SUBJECT: SAFETY RECALL OF 2011 MCI J & E MODEL COACHES WITH DOGA WINDSHIELD WIPER MOTORS

Ref.: **NHTSA # 11V-379**
TRANSPORT CANADA #TC 2011-275
MCI Service Bulletin 362

Service Bulletin No. 362

MODEL E / J Series Coaches	TYPE Field Change Program	SECTION/GROUP 7-- Electrical	DATE Aug. 02, 2011
SUBJECT DOGA WINDSHIELD WIPER MOTOR FUSE			
CONDITIONS

Figure 1.

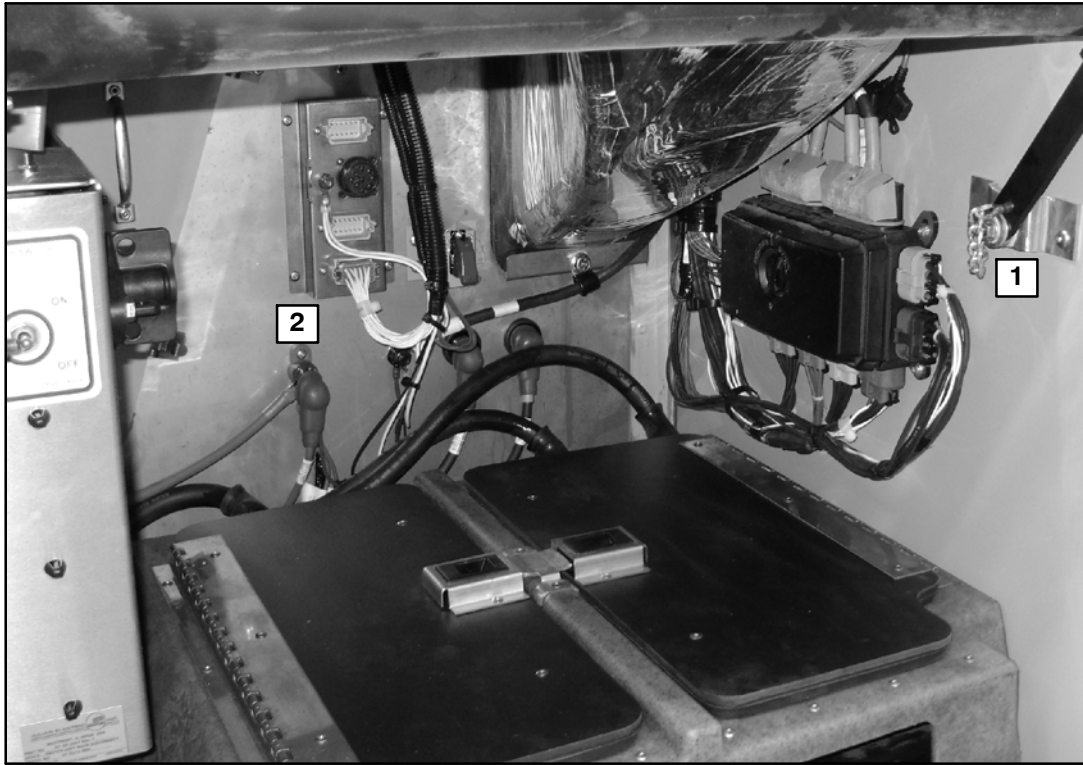
1. Open the battery compartment door. Install the positive lock pin in the hole of the hinge to secure the door in the open position (refer to Figure 1).
2. Activate the disconnect feature of the main battery disconnect (MDS) system by pressing (for one second only) the momentary toggle switch on the MDS module to OFF. An audible click can be heard from the main solenoids in the MDS module. Position the rotary switch to the DOWN (OFF) position.
3. Chock both sides of the tires.

4. Locate the 24V HOT power stud block on the back compartment wall (refer to Figure 1).

Figure 2.

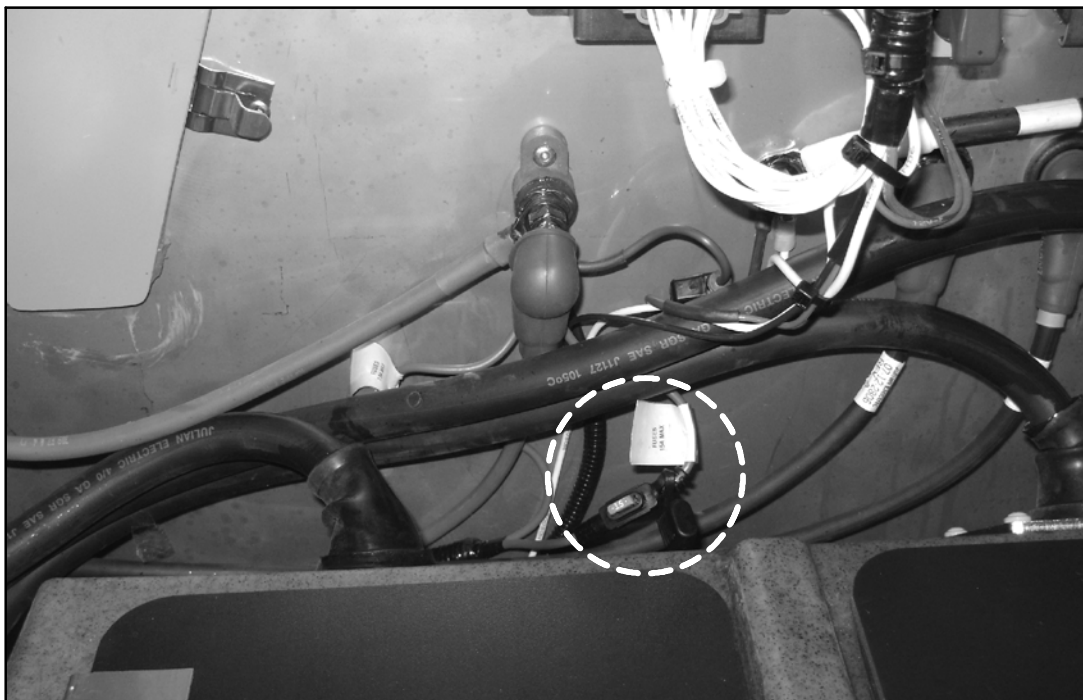
5. Locate the inline fuse routed from the 24V HOT power stud block with the decal labelled either FUSE5 15A MAX, or 30A MAX. BATT HOT (refer to Figure 2).

Figure 3.

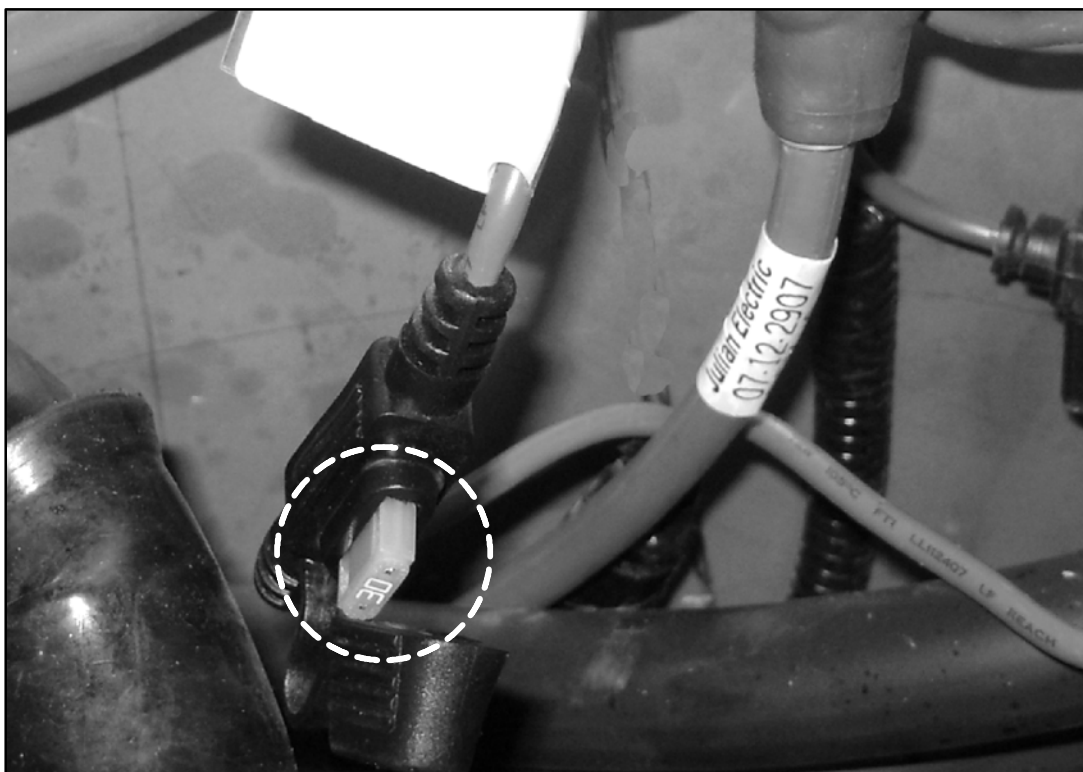
6. Remove the protective flip–cap. Visually inspect to verify that a 30 AMP fuse is installed (refer to Figure 3).

If a 30 AMP fuse is installed, press to secure the flip–cap over the fuse. Visually inspect to verify that the decal text is 30A MAX BATT HOT. If not, install a new 30A decal, p/n 07-08-4061. Close the battery compartment door. Procedure complete.

If a 15 AMP fuse is installed, carefully remove the 15 AMP fuse and install a 30 AMP fuse, p/n 07-08-2176. Press to secure the flip–cap over the 30 AMP fuse. Remove the existing 15A decal and install a new 30A decal, p/n 07-08-4061. Close the battery compartment door. Procedure complete.
